# Rufus 2.0 - Block 19

## Purpose of Recommendation Meeting #3

FIGURE 3A

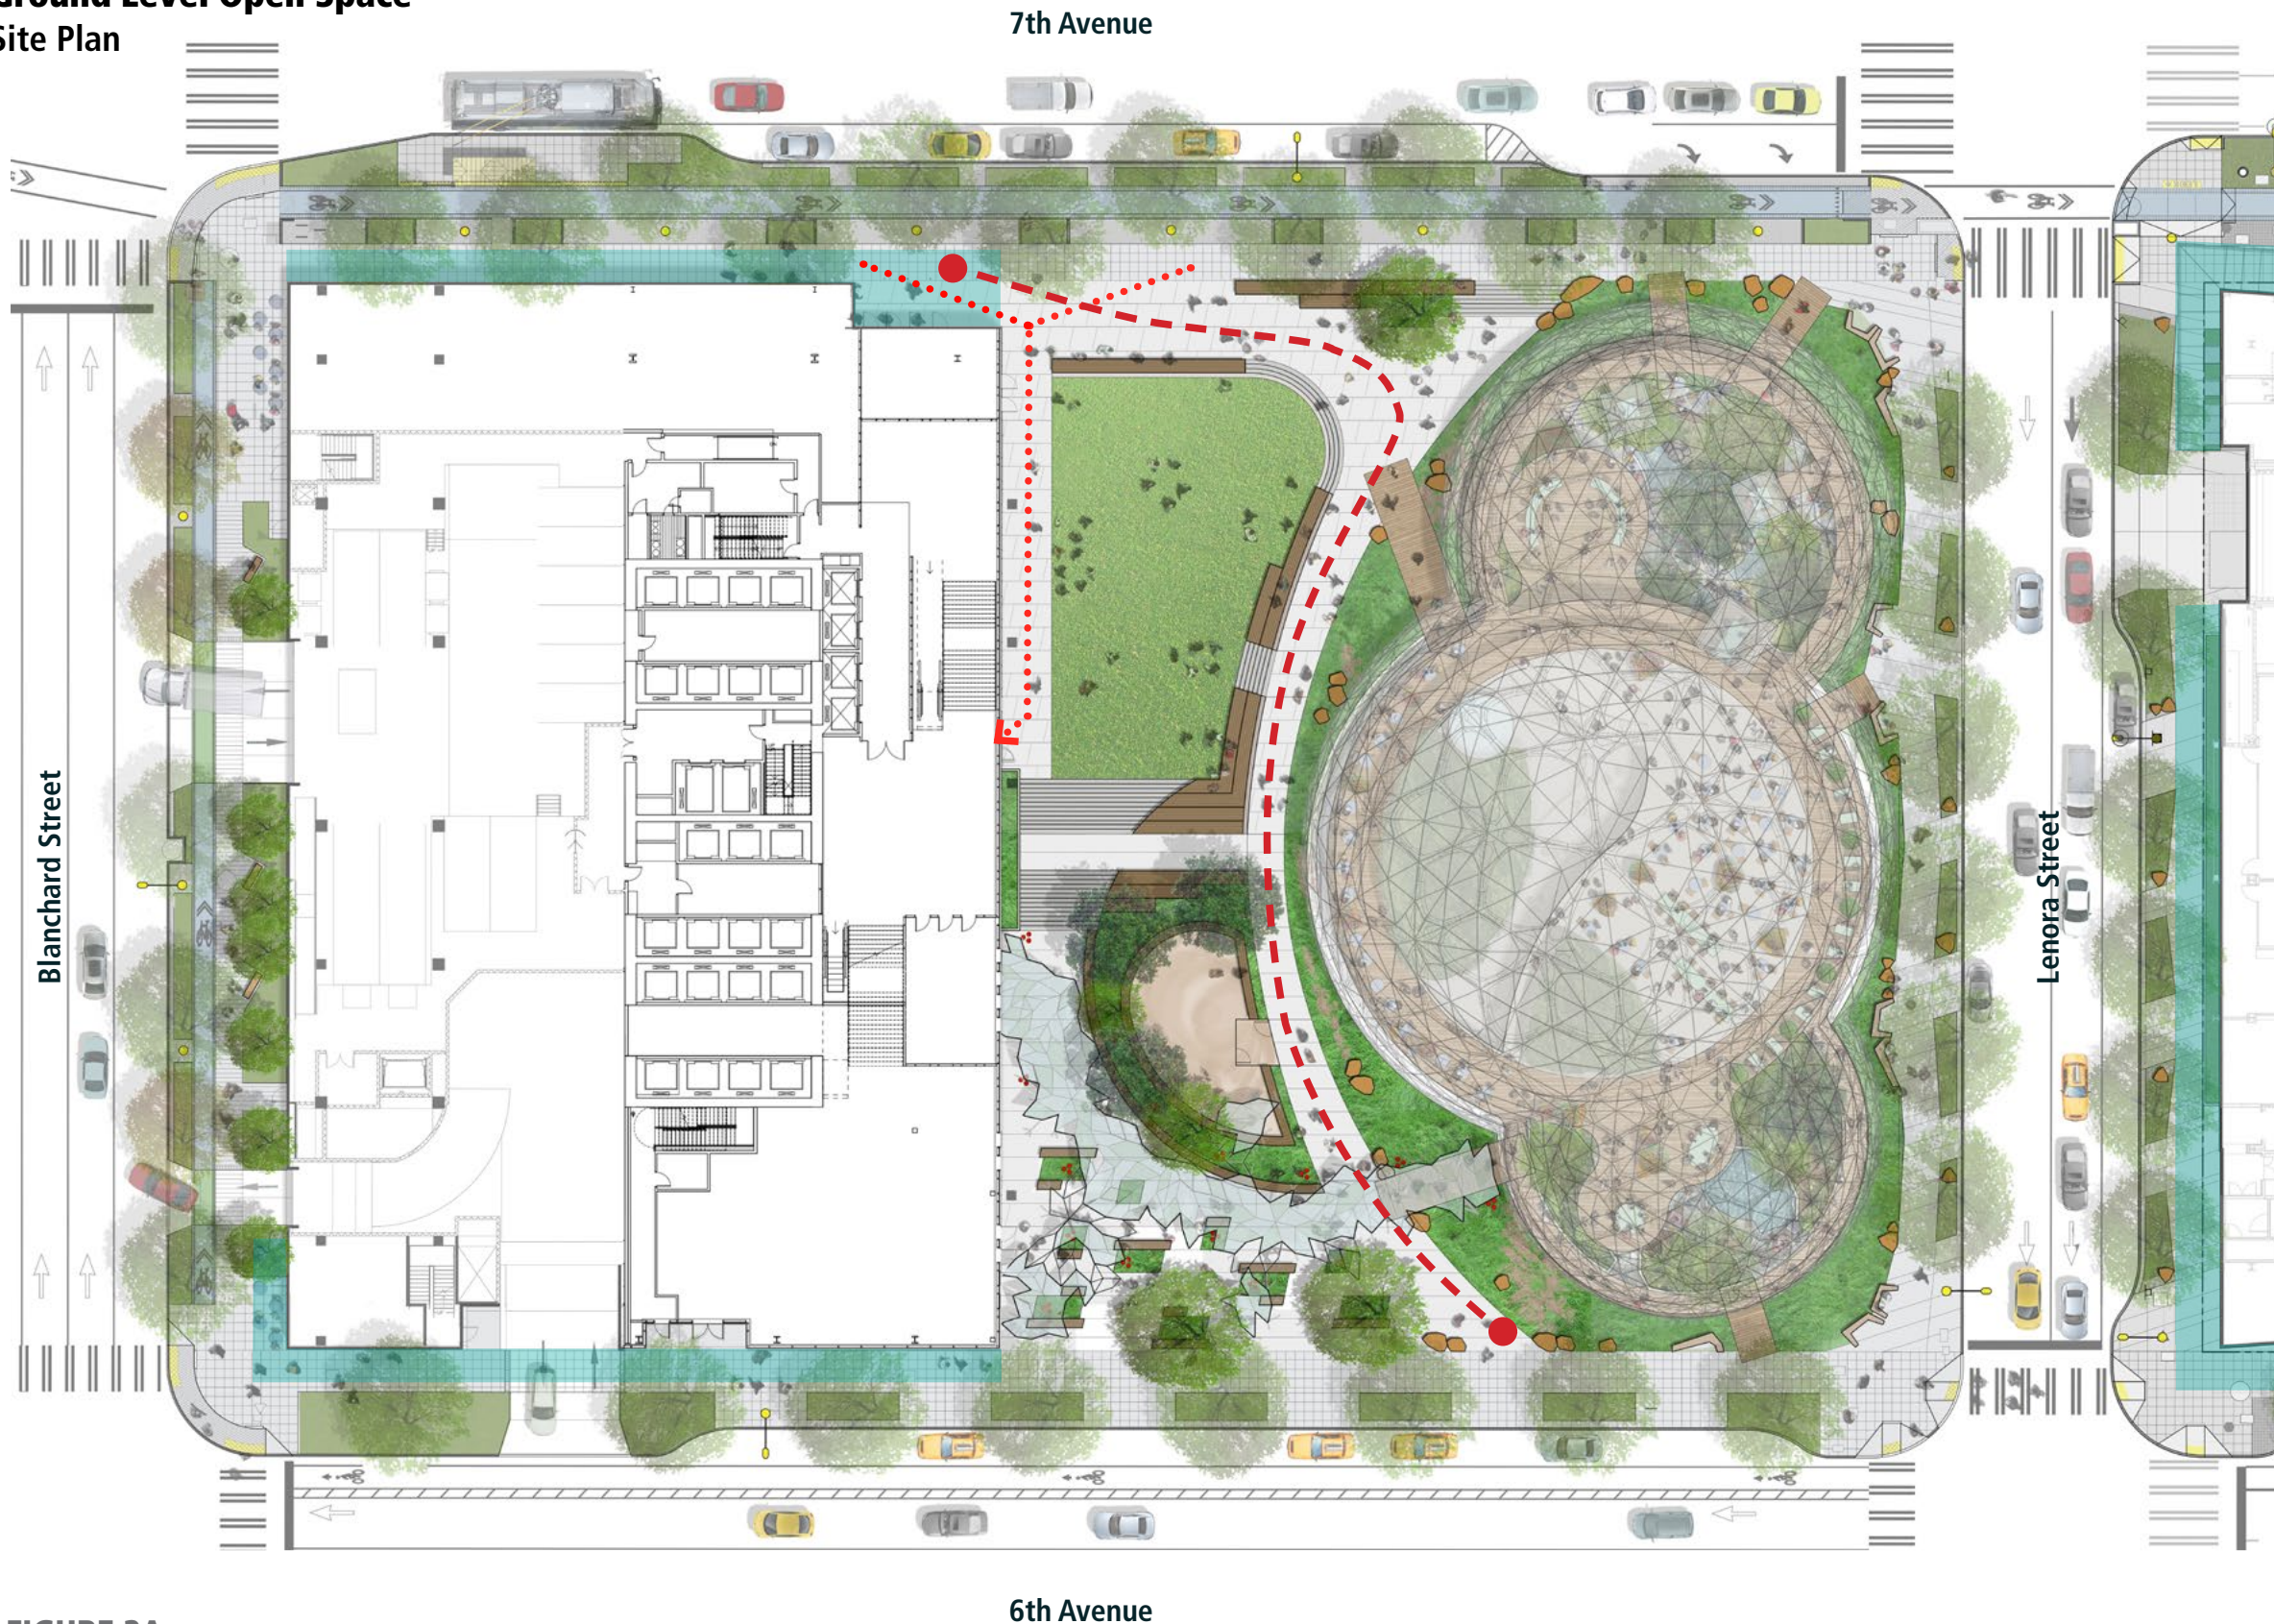
b. The Board felt, however, that overhead protection should be provided at the entry points or at the seating areas along Lenora. The Board also encouraged enhancing the overhead protection across Lenora on Block 14. (C-5)

Recessed alcoves provided at all entry points to the Spheres offer overhead weather protection as shown in Figure 4B. Across Lenora, continuous overhead weather protection is provided by canopies along the Meeting Center facade as shown in Figure 3A.

FIGURE 3B

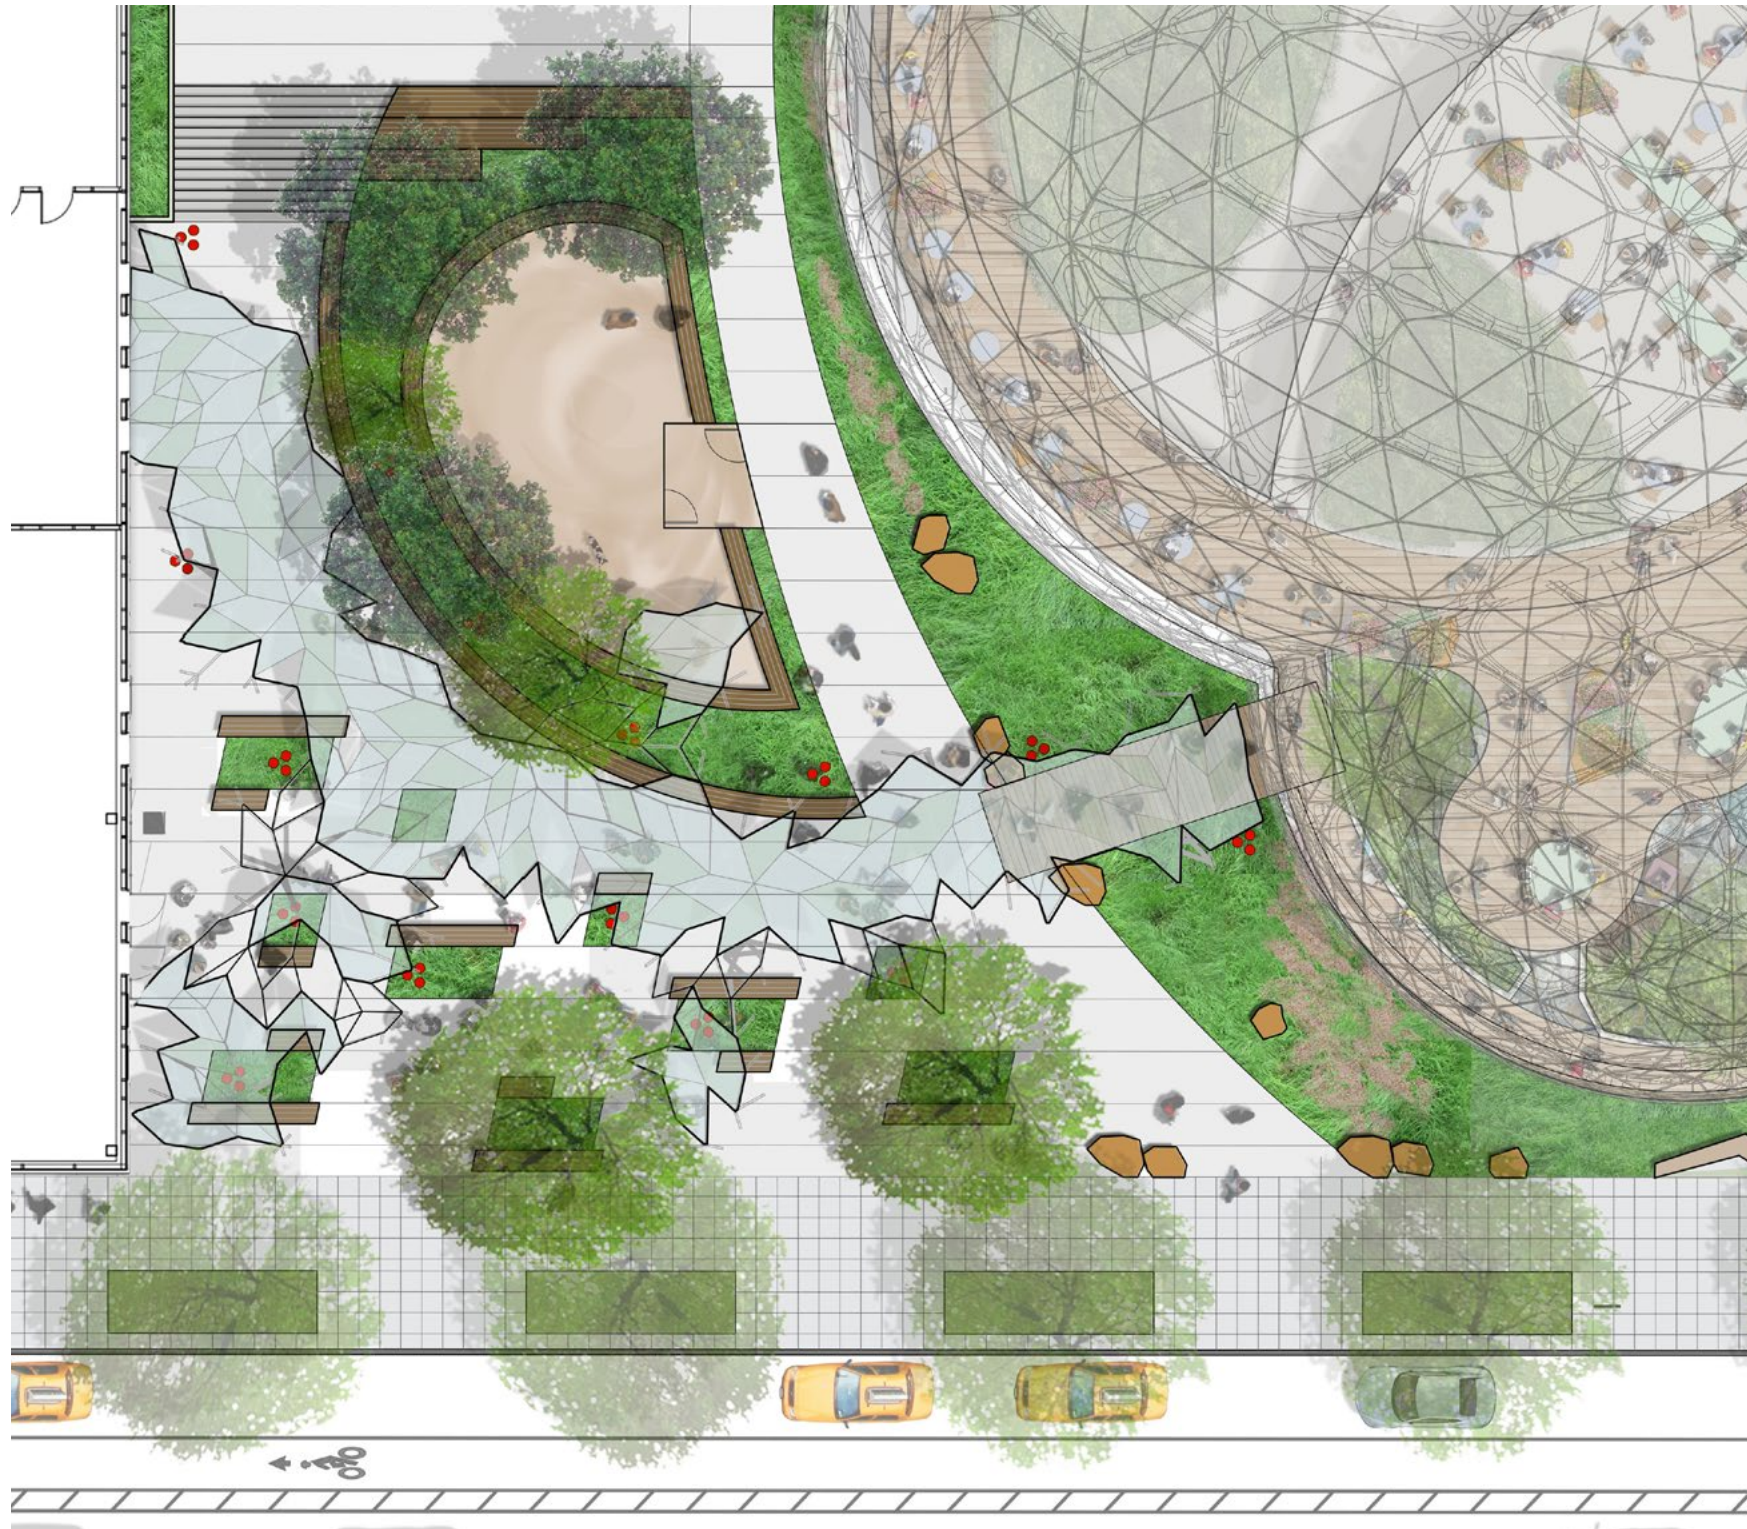
a. The Board noted that the canopy structure connecting the spheres to the tower may be too thin in comparison with the structural members of the spheres. The Board encouraged the canopy fabrication system be expressed as a continuation of the sphere's internal structures. (C-1, D-1, D-2)

Conceptually, the canopy is born out of the idea of an unfolded catalan sphere. When unfolded, the loads of the skin system can be supported in a much more efficient manner than by using the heavy catalan module used inside the Spheres. See Figures 3B,D,E & F for diagrams showing the current design direction of the canopy.

FIGURE 3C

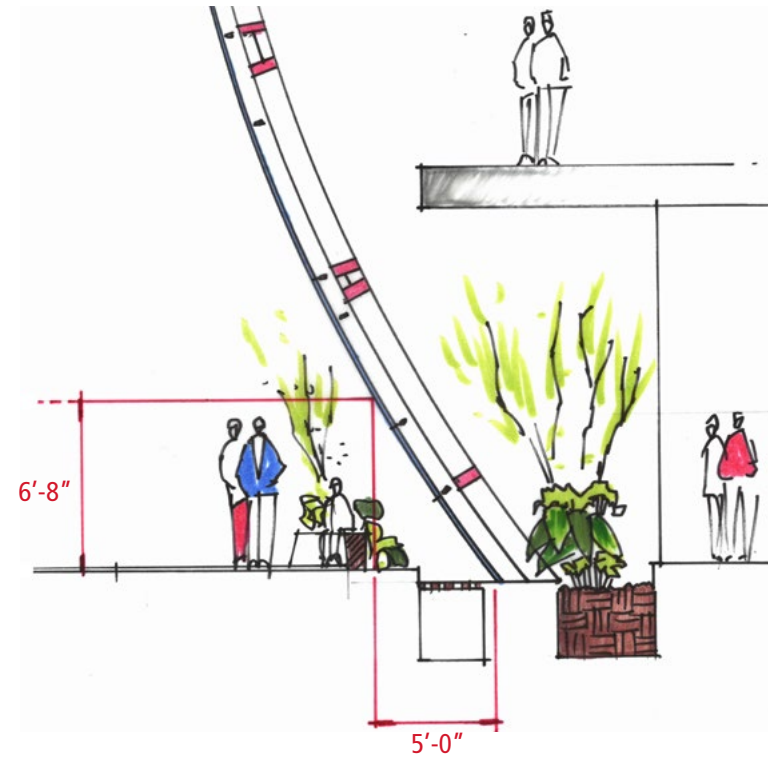
c. The Board encouraged the vegetated buffer surrounding the perimeter of the building be less homogeneously dimensioned and instead be varied to create more organic shaped planting beds, as well as to respond to specific ground level conditions, such as entry pathways. The Board suggested inclusion of specific locations where pedestrians can come right to the building façade on hardscape, to encourage public interaction with the development. (C-1, D-1, D-2)

Areas are provided at each entry point of the Spheres which allow anyone to stand on hardscape and experience the Spheres close up. Due to the inwardly curving nature of the Spheres as they meet the ground, other points of interaction are restrictions by ADA requirements as shown in Figure 3C.

FIGURE 3G

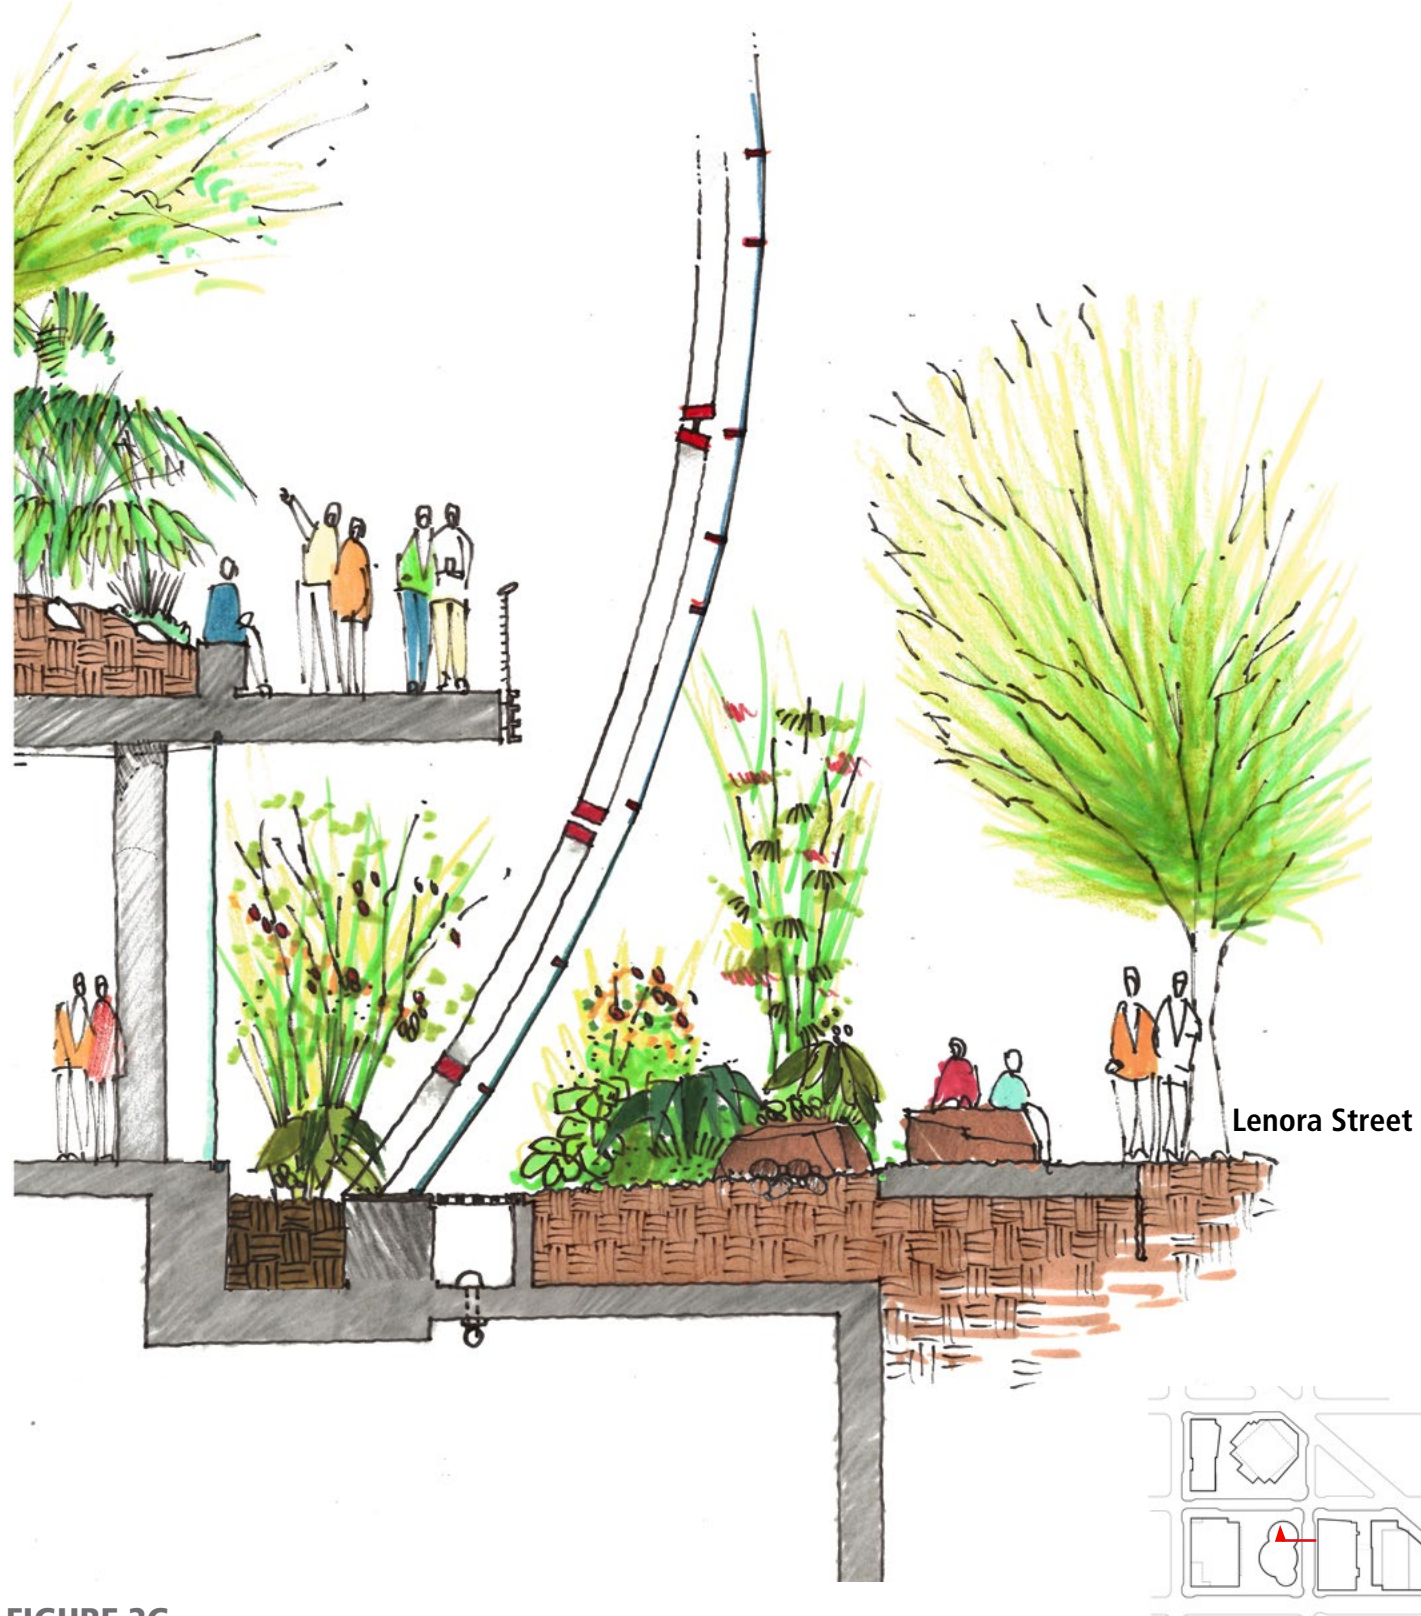
d. The Board would like to see detailed sections of the Lenora experience at the next meeting (similar to page 20 of the booklet) showing sidewalk, landscaped and hardscaped area, and building section. (C-1, D-1, D-2)

Detailed sections shown in Figures 3G and 3H and a physical section model shown in Figure 2A have been provided.
